Overview: Production error; immobilizer wire (orange/black) in pin position #4 instead of pin position #5. Although an effort to correct the issue was made, some quantity of harnesses did get shipped before the issue was spotted. We are advising to inspect the harness BLADE connector before attempting to install the harness and program the module.

Overview: The FTI-STP1 harness may require modification for use in **automatic transmission (AT)** applications, some of the product was able to be modified before release, but a small quantity was released before being able to be modified internally.

FTI-STP1: Vehicle Coverage and Preparation Notes

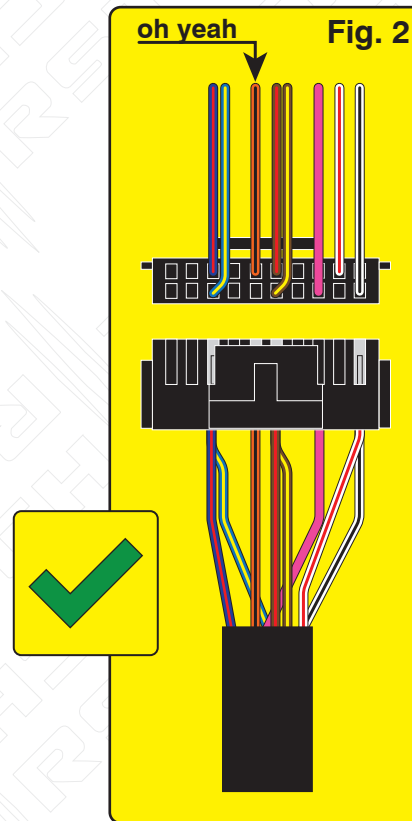
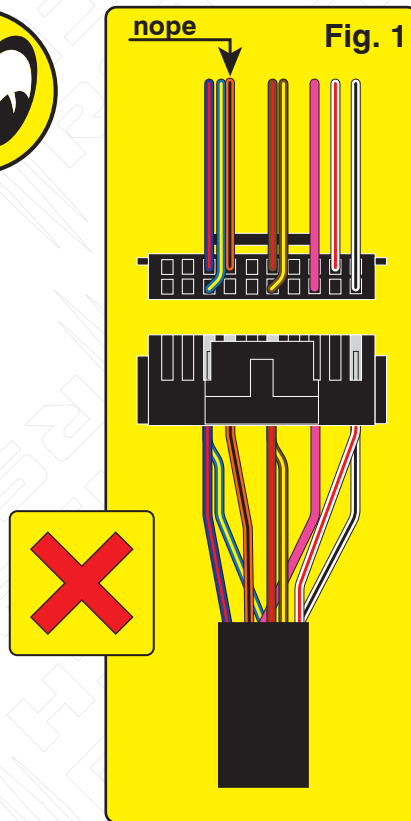
Correction: Step 1.) Locate the orange/black wire and confirm whether it is positioned as illustrated in Fig. 1 or Fig. 2. If the wire is as illustrated in Fig.1, proceed with Step 2 through 5 and complete the repair procedure outlined, if the wire is as illustrated in Fig. 2, correction is not necessary, proceed with harness installation and module programming.

Step 2.) Using a pick, lightly depress the catch that secures the terminal in the housing then remove the wire and terminal from the housing.

Step 3.) Using a fine tip razor or utility knife, insert the blade beneath the terminal catch and raise it slightly, so that it can be reused to secure the terminal when reinserted into the BLADE connector housing.

Step 4.) Refer to Fig. 2 for correct position of the orange/black wire (next to brown/red) then reinsert the terminal, pressing lightly until the catch 'snaps' into place, securing the terminal in the connector housing.

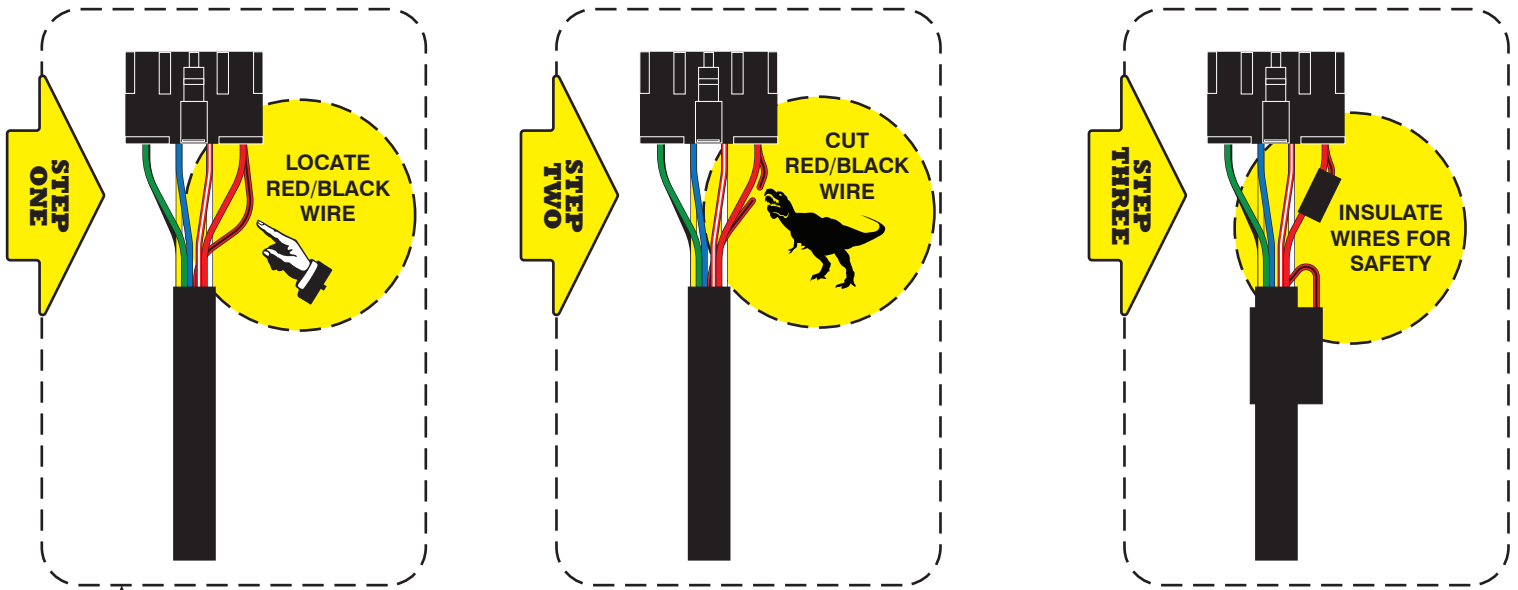
Issue: The FTI-STP1 T-harness has been designed to be compatible with AT (automatic transmission) & MT (manual transmission) applications, but due to a production oversight, the selection mechanism was defaulted to MT mode.

Using a harness configured for an MT application, in an AT equipped vehicle, could result in vehicle module damage, it is advised that the harness be returned to AT mode before installation in vehicles equipped with an automatic transmission.

Correction: Locate the **red/black (+ Clutch)** wire provided in the CN1 connector of the main harness assembly. Cut the **red/black** wire, either flush to the CN1 connector, or leaving enough wire exposed so that you can insulate and secure the ends of the wire that remain after cutting. Insulate each of the remaining ends of the **red/black** wire and secure to prevent any possibility of a short circuit.

If the red/black wire already been disconnected, no further modification is required for AT equipped vehicles.

MODIFICATION REQUIRED FOR AUTOMATIC TRANSMISSION APPLICATIONS ONLY

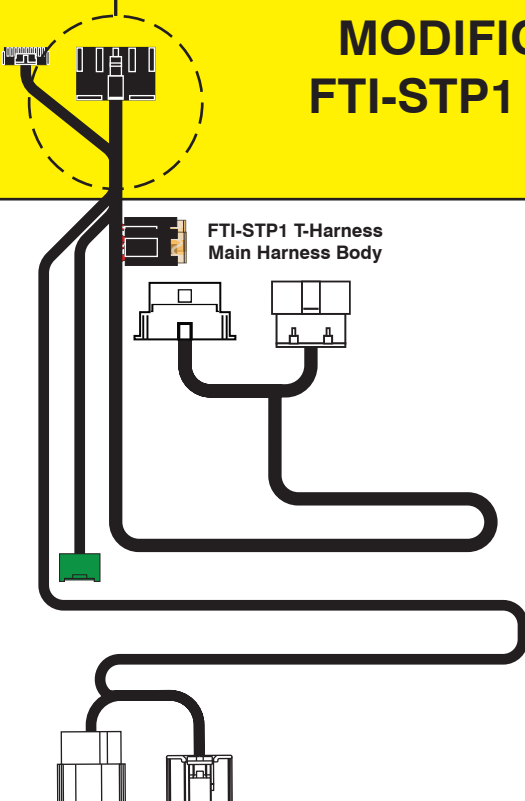
MODIFICATION NOT REQUIRED WHEN USING FTI-STP1 HARNESS IN MANUAL TRANSMISSION APPLICATIONS
